CERTIFICATE OF THE SECRETARY OF ENERGY AND ENVIRONMENTAL AFFAIRS
ON THE
ENVIRONMENTAL NOTIFICATION FORM

PROJECT NAME : Gardner Sludge Landfill Expansion
PROJECT MUNICIPALITY : Gardner
PROJECT WATERSHED : Millers River
EEA NUMBER : 16643
PROJECT PROPONENT : City of Gardner
DATE NOTICED IN MONITOR : December 23, 2022

PLAN of TAKING by the TOWN OF GARDNER for Cemetery and Park Purposes

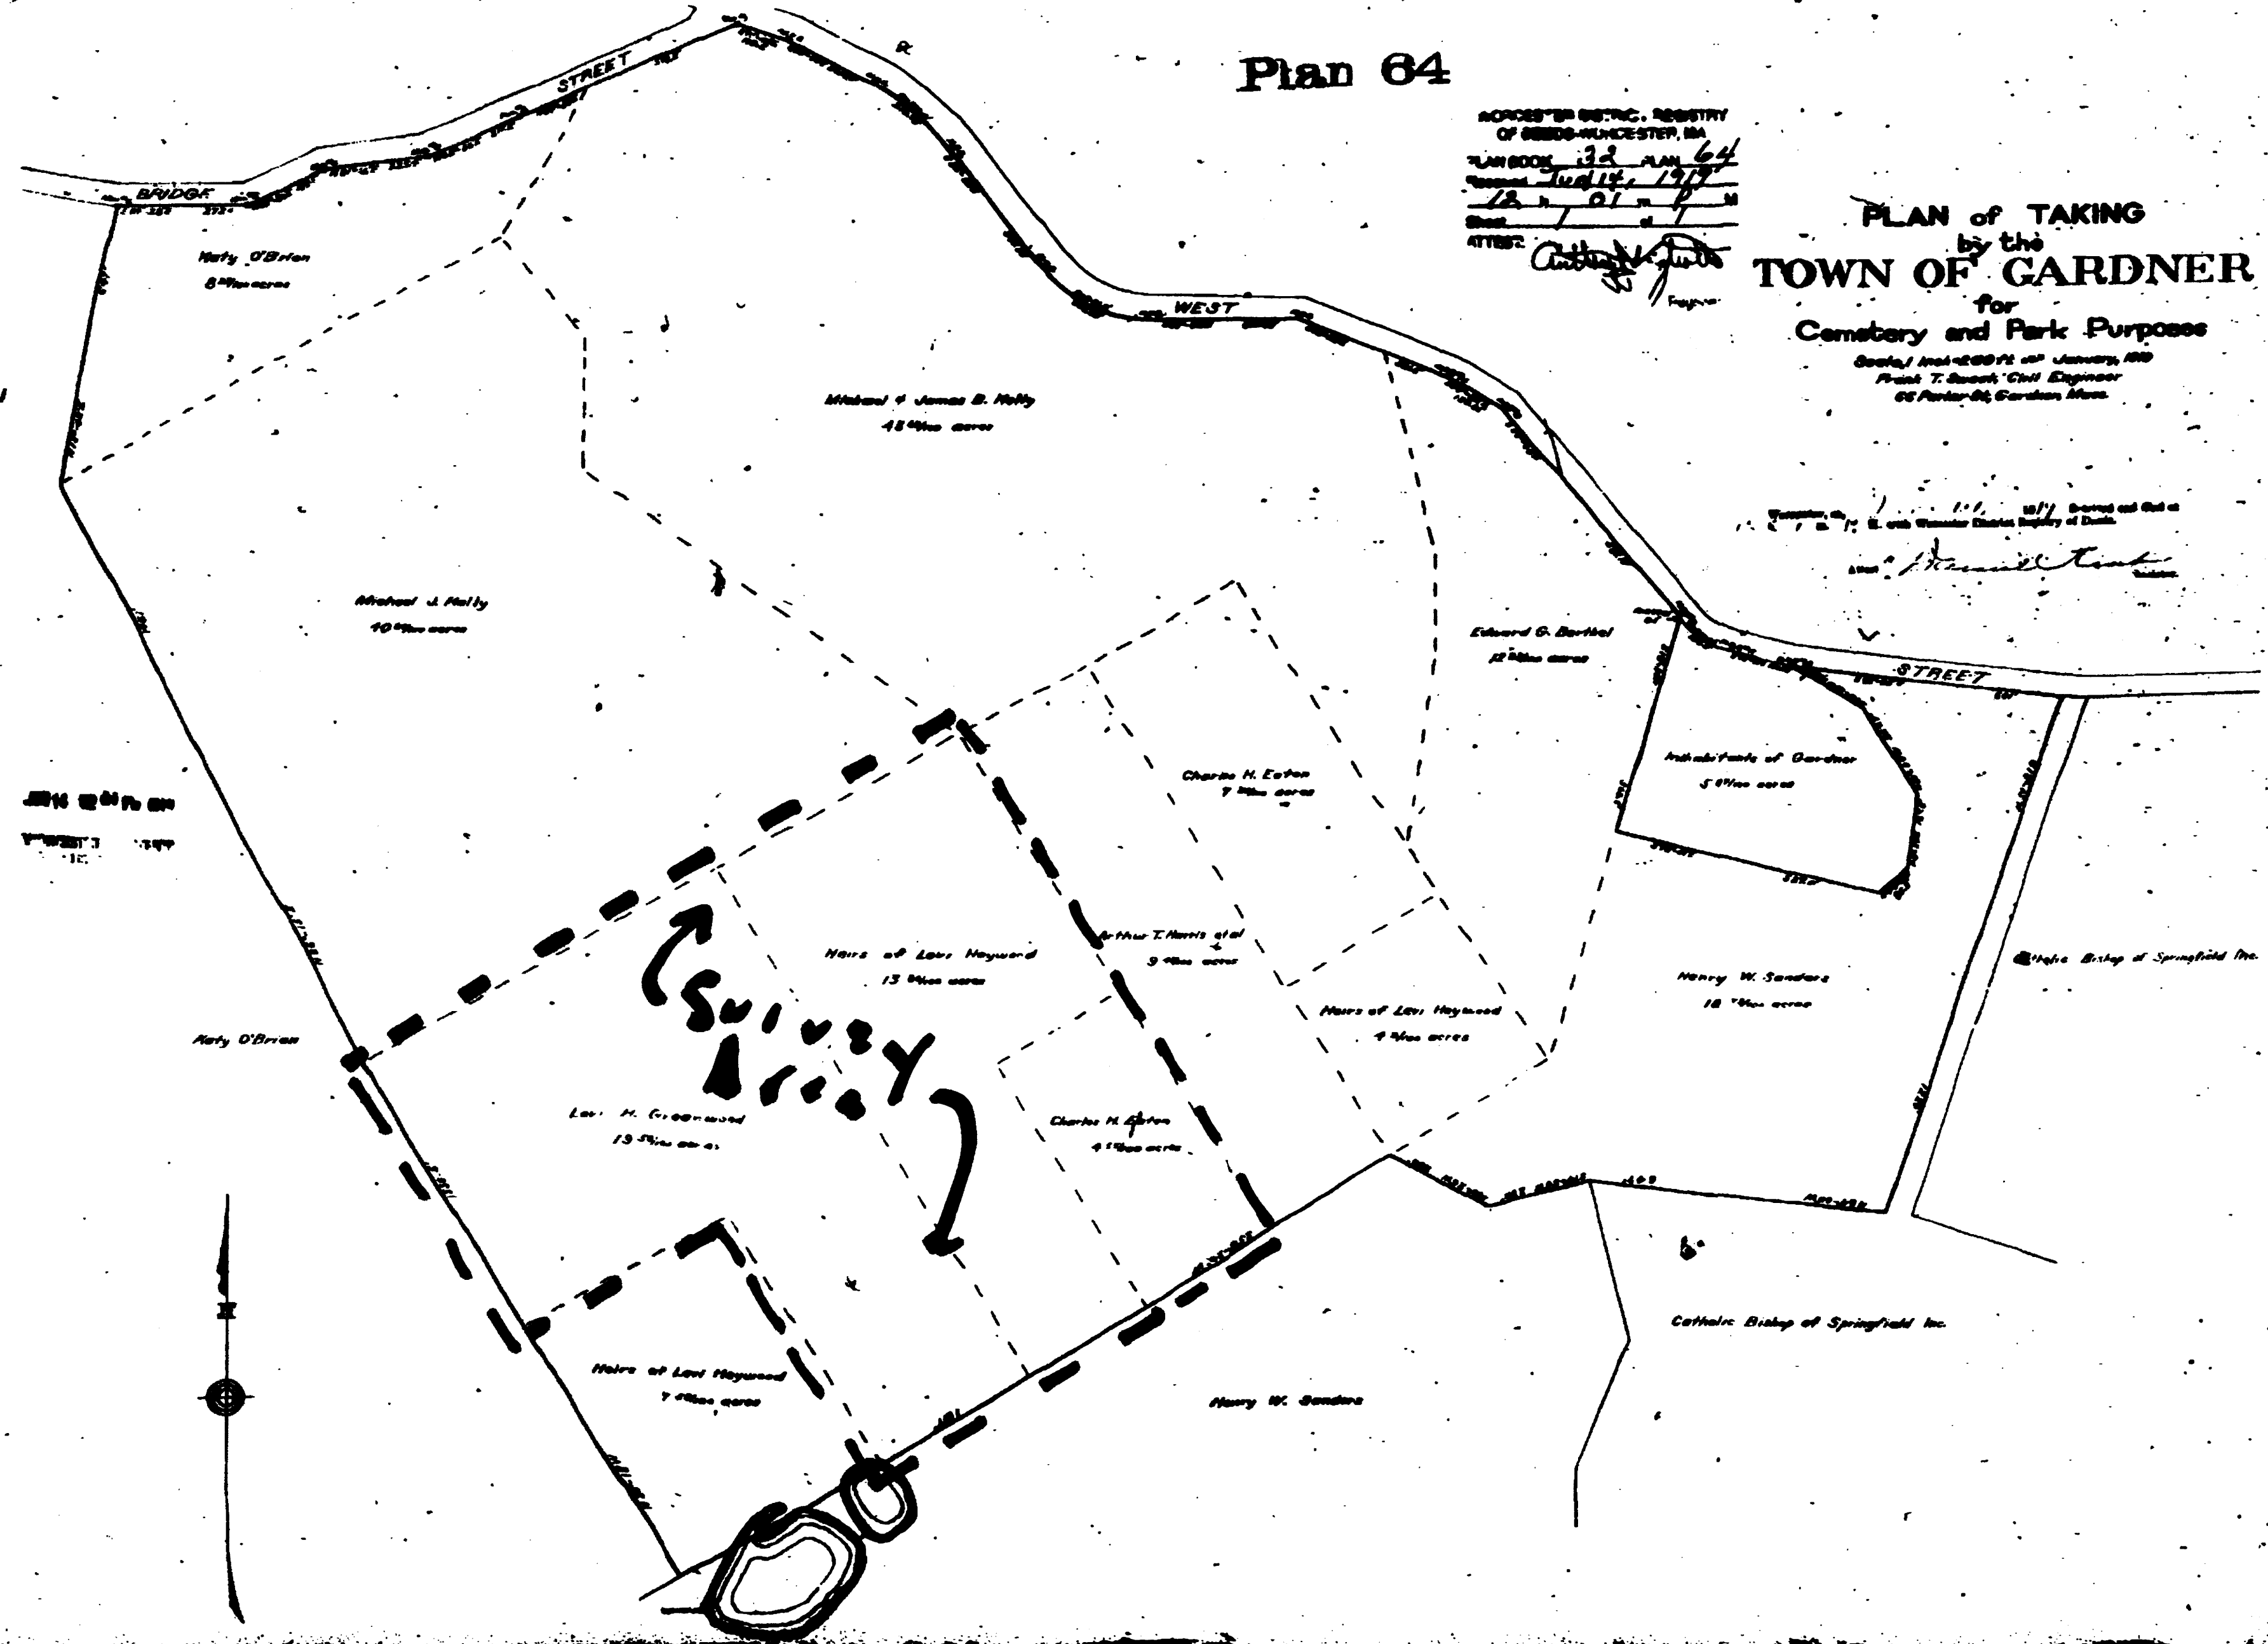
12. **Article 97 checkbox should be marked Yes:** Item II.D of the ENF’s Land Section asks: “Does any part of the project involve conversion of land held for natural resources purposes in accordance with Article 97 of the Amendments to the Constitution of the Commonwealth to any purpose not in accordance with Article 97?” This box should have been checked Yes: This project involves conversion of land held for natural resources purposes in accordance with Article 97 of the Amendments to the Constitution of the Commonwealth.—**See attached “Plan of Taking by the Town of Gardner for Cemetery and Park Purposes” dated July 14, 1919.**

II. D. This project involves conversion of land held for natural resources purposes in accordance with Article 97 of the Amendments to the Constitution of the Commonwealth. See attachment #3 “Plan of Taking by the Town of Gardner for Cemetery and Park Purposes” dated July 14, 1919.
